## ADDENDUM NO. 2

### Demolition for Future Lincoln Entertainment Center City of Lincoln Lincoln, Nebraska

PROJECT: SPECIFICATION NO. 03-158  
REGA NO. 031001

**SECTION A-A**  
 (SHEET C-7, SITE FINISH CROSS-SECTIONS)  
 HORIZ. SCALE: 1"=40'  
 VERT. SCALE: 1"=40'

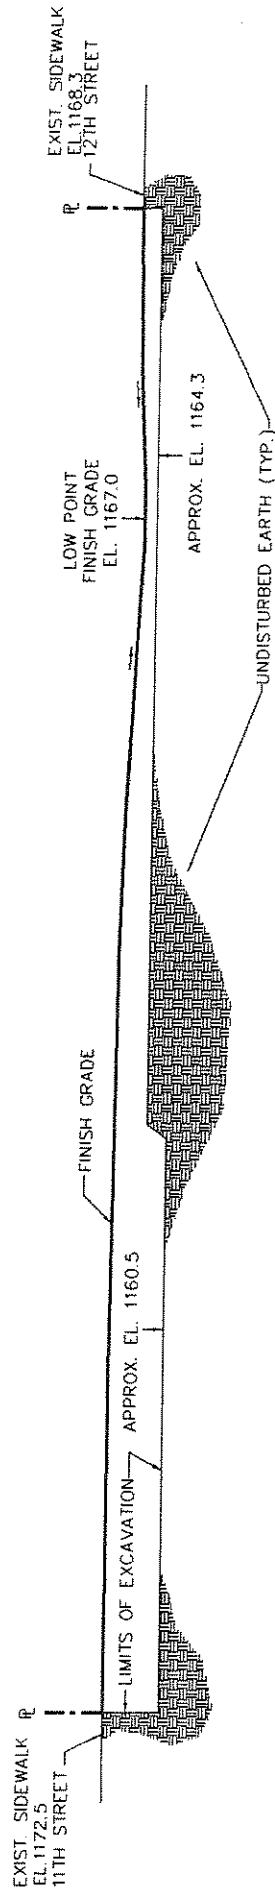
SHEET C-7, SITE FINISH CROSS SECTIONS

Delete: Section A-A

**Add: Exhibit C, Section A-A**

**Add: Title to untitled cross section. Section C-C**

## TYPICAL PAVEMENT REPLACEMENT FOR UTILITY ABANDONMENTS

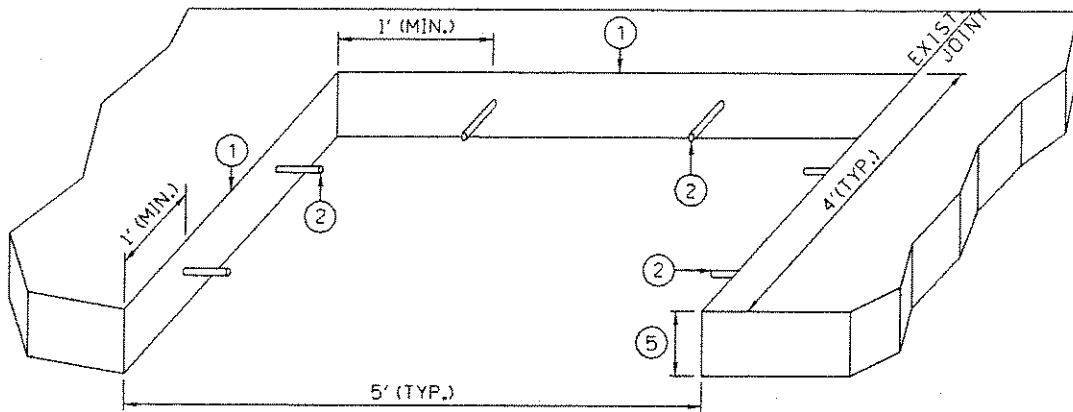
SHEET C-6, MISCELLANEOUS DETAILS

**Add: Exhibit E, Typical Pavement Replacement for Utility Abandonment's**

- ① FULL DEPTH DIAMOND SAWCUT
- ② INSTALL #5 X 18" DOWEL BARS ON ALL EDGES AT 30" CENTERS (MAX.) DRILL AND GROUT INTO EXISTING PAVEMENT
- ③ PAVEMENT REMOVAL SHALL BE PERFORMED ALONG LINES OF EXISTING JOINTS WHERE POSSIBLE.
- ④ ALL CONCRETE SHALL CONFORM TO THE REQUIREMENTS OF THE CURRENT STANDARD SPECIFICATIONS OF THE NEBRASKA DEPARTMENT OF ROADS FOR 47B CONCRETE.
- ⑤ THICKNESS OF NEW PAVEMENT SHALL BE THE SAME AS EXISTING PAVEMENT.
